# ZONING MAP AMENDMENT STAFF REPORT SARASOTA MEMORIAL HOSPITAL

May 7, 2019

18-09RZ

**PETITION NO.:** 18-09RZ  
**REQUEST:** Zoning amendment to revise the existing Planned Commercial Development (PCD) district zoning of the subject property to allow for the proposed uses of hospital and related healthcare facilities.

### Minimum Parking Space Dimensions

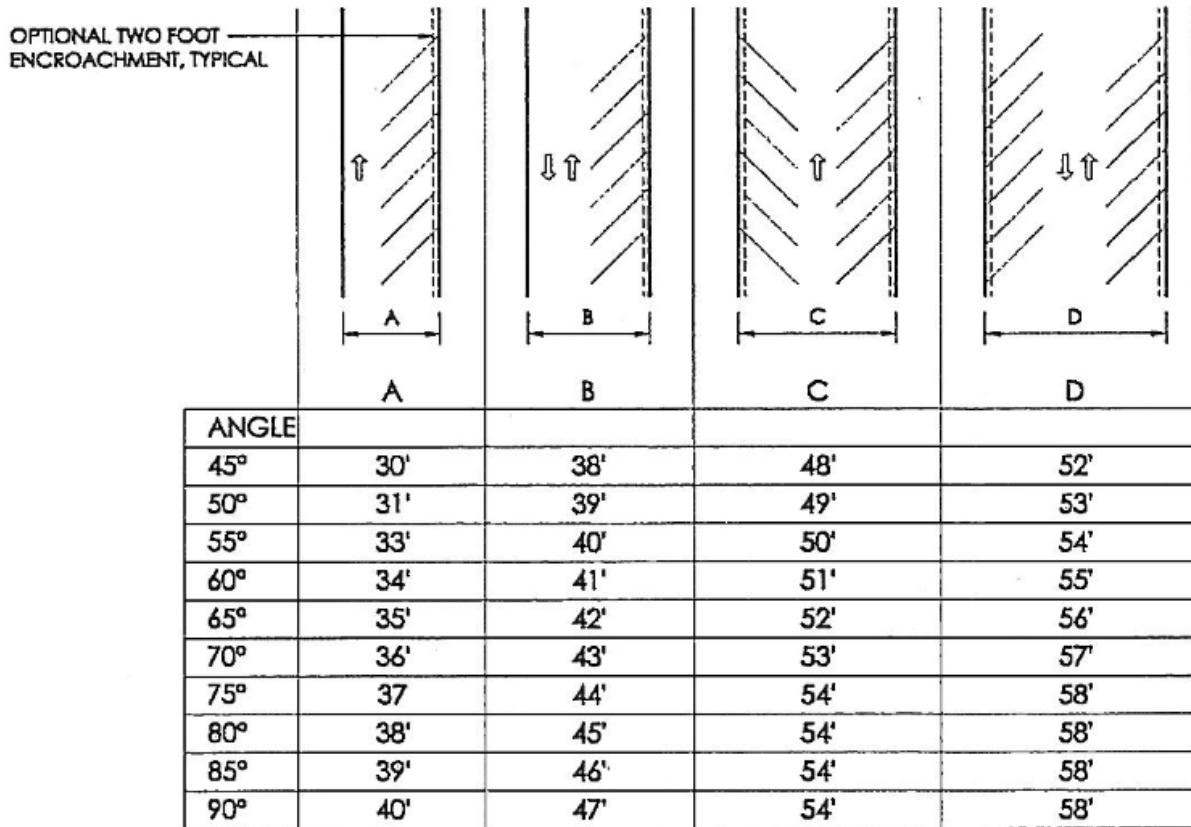
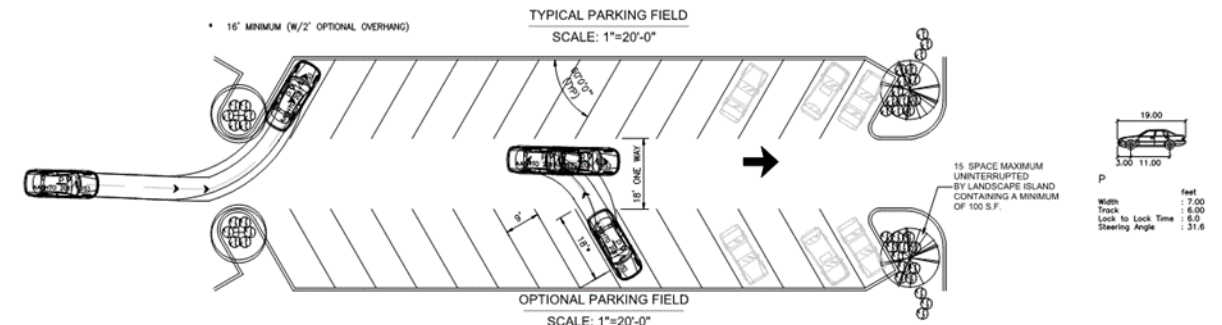
7. Modification of Code Section 86-412 regarding parking drive aisle width.  
**Staff Comment:** *The applicant requests to reduce the drive aisle width for one-way traffic from the required 20 feet to 18 feet for an optional parking field design provided on sheet 4 of 4 in the binding master plan. The applicant has provided an example from the City of Sarasota's code to justify their*

Angle of Parking	Aisle Width (feet)	
	One-Way	Two-Way
Parallel	<del>20</del> 18	20
30°	<del>20</del> 18	22
45°	<del>20</del> 18	22
60°	<del>20</del> 18	24
90°	<del>20</del> 18	24
Entrance/exit	20	24
Parking access drives	<del>20</del> 18	24

As reference the City of Sarasota Code Section-209, for a one way 45° a minimum drive aisle of 12 (48 feet total aisle width – 18 feet for each side) feet is allowed and up to a 90° a minimum 18 feet (54 feet total aisle – 18 feet for each side) is allowed.

Below is a representative exhibit showing the maneuverability of a vehicle utilizing an 18-foot wide drive aisle.
